Vermont Agency of Transportation
RECEIVED
CK'D BY FDB OK'D BY HIS
June 29, 2015
RESUBMIT No Approved
BY Carolyn Carlson DATE 06/29/15

G.W. TATRO CONSTRUCTION, INC.
VT/AOT BRIDGE REPLACEMENT— ROAD IMPROVEMENT RICHFORD, VT.

26' SPAN X 10' RISE 3-SIDED CULVERT

Drawing No: C22312-101B

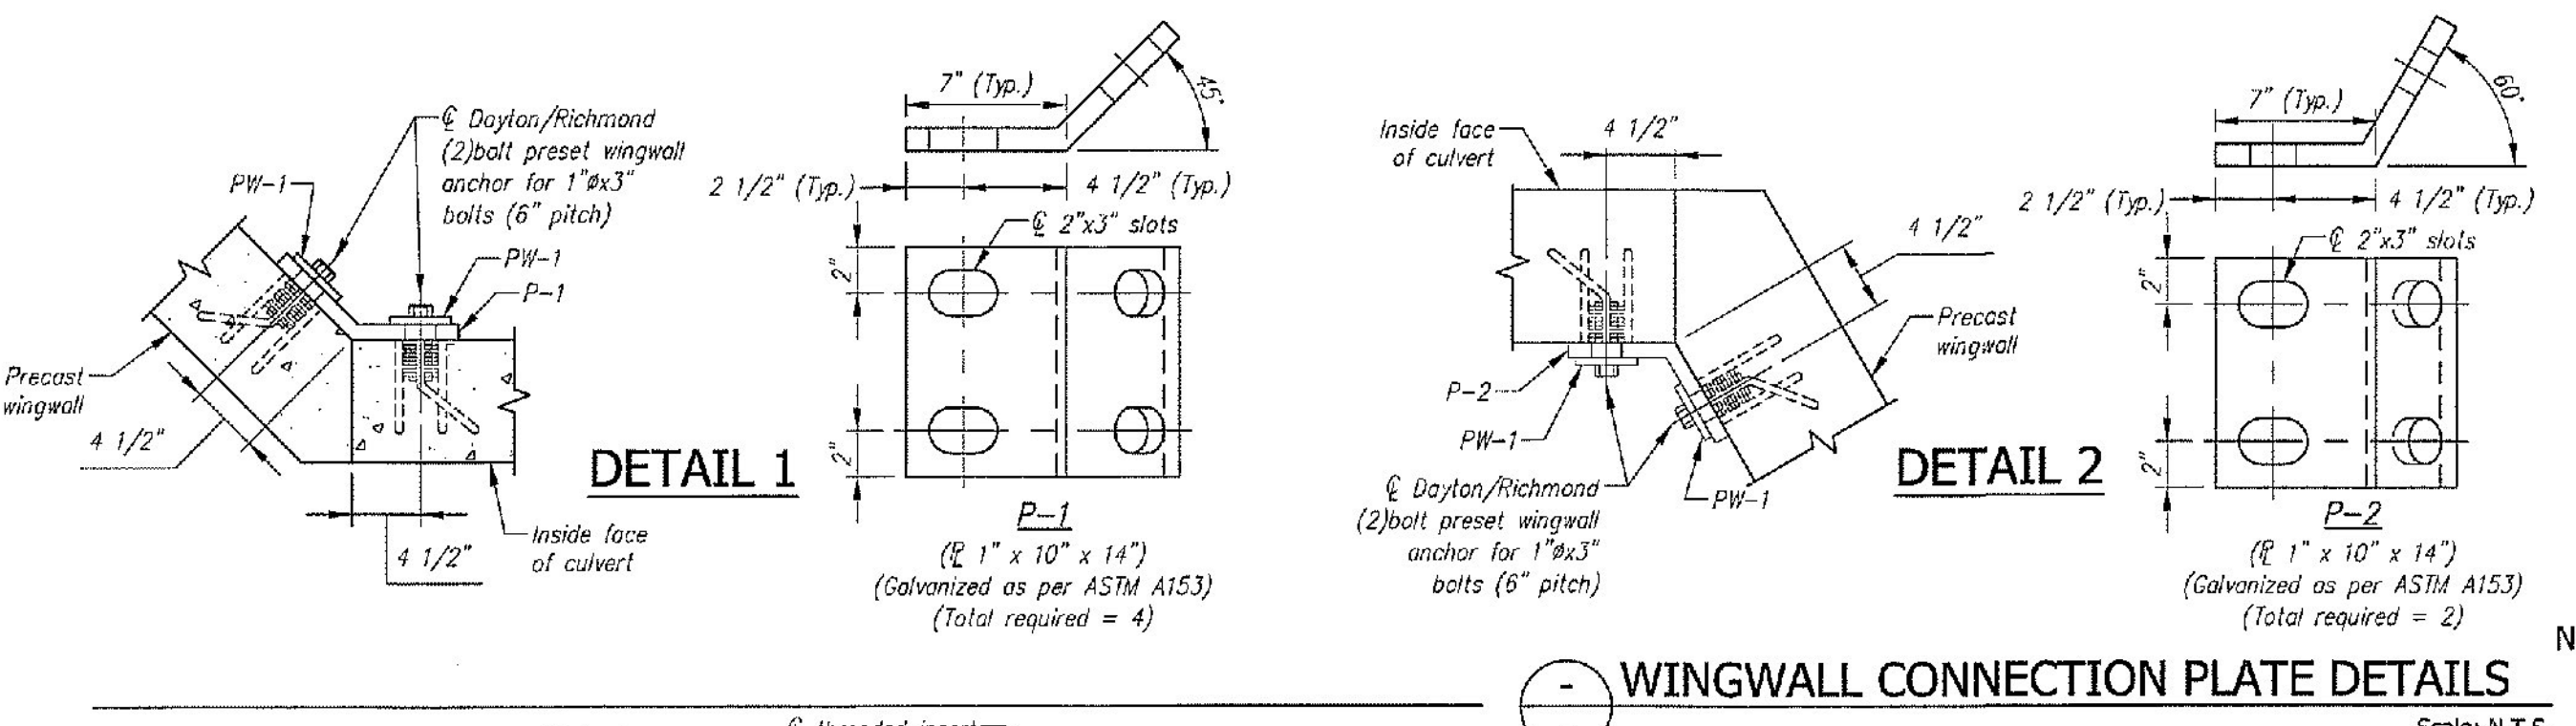
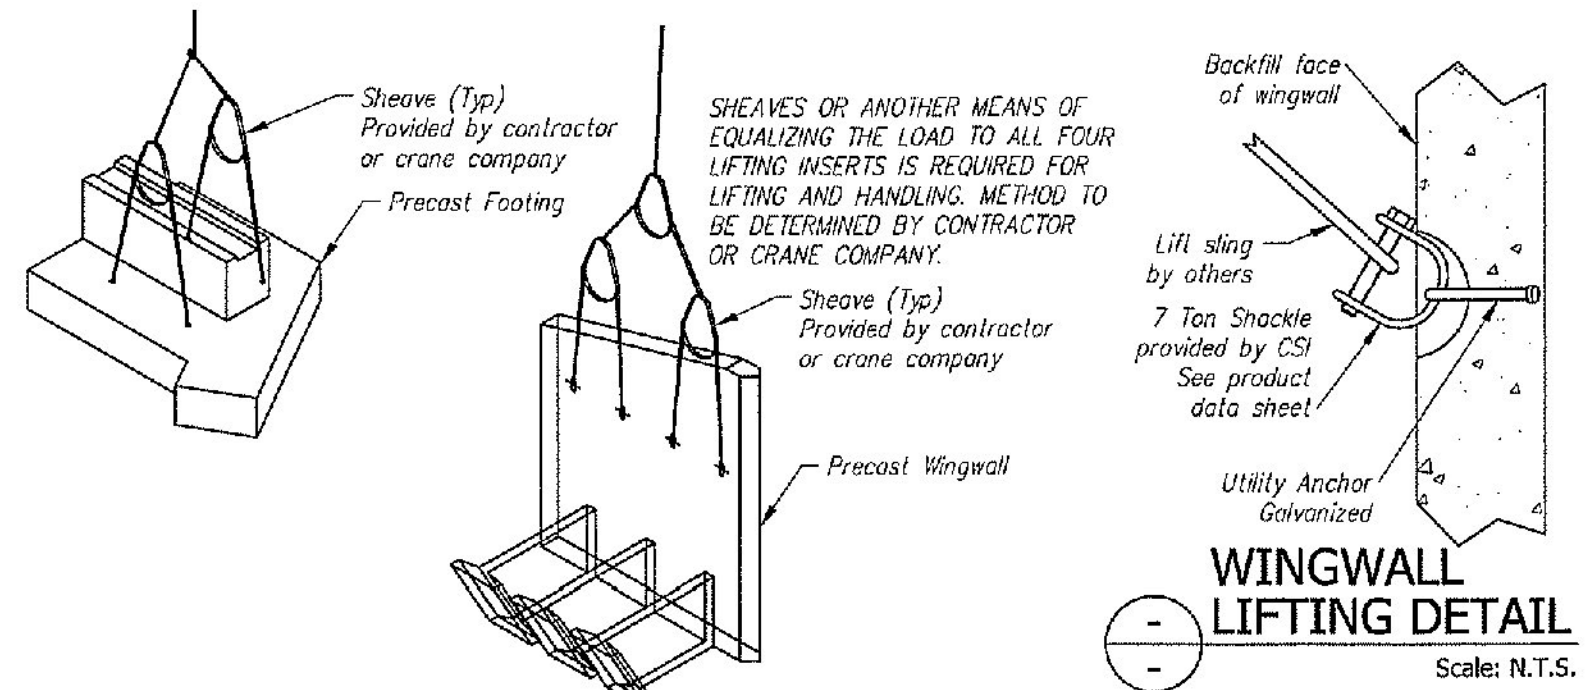
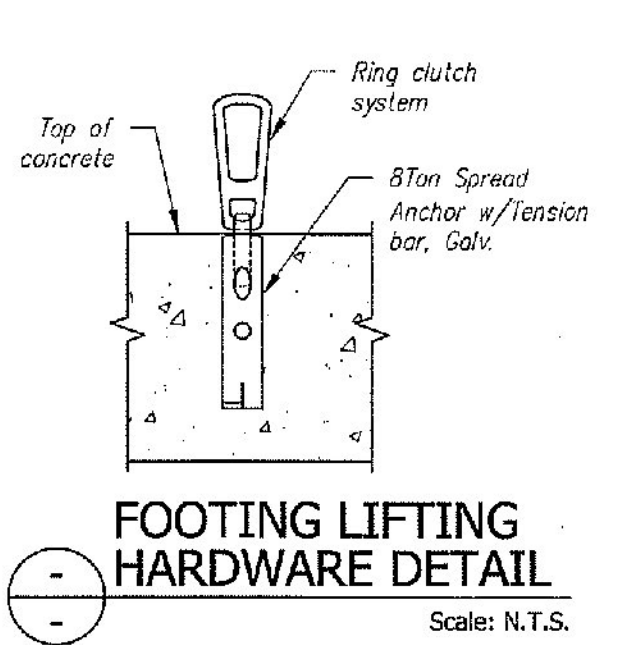
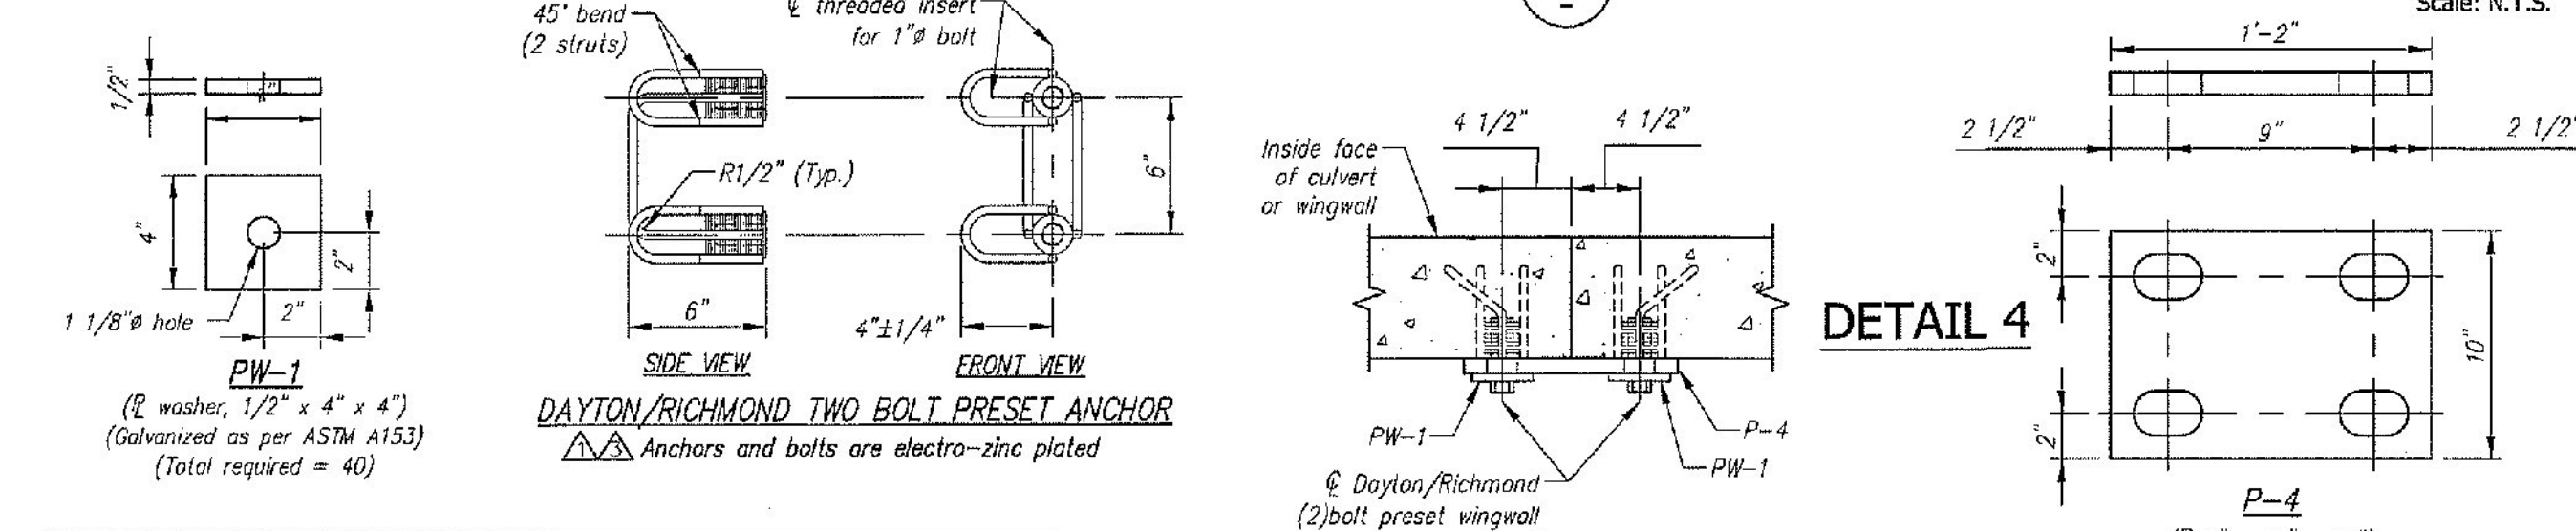
Rev.	Date	DESCRIPTION	By
7			
6			
5			
4	17JUN2015	REVISED PER CUSTOMER REVIEW	BSS
3	04JUN2015	REVISED PER CUSTOMER REVIEW	RY
2	28MAY2015	EL A-A & B-B: 437.17 WAS 437.13, EXTENDED WINGWALLS EVEN WITH HEADWALL	RY
1	14MAY2015	REVISED PER CUSTOMER REVIEW, SEE SHEET 1	RY
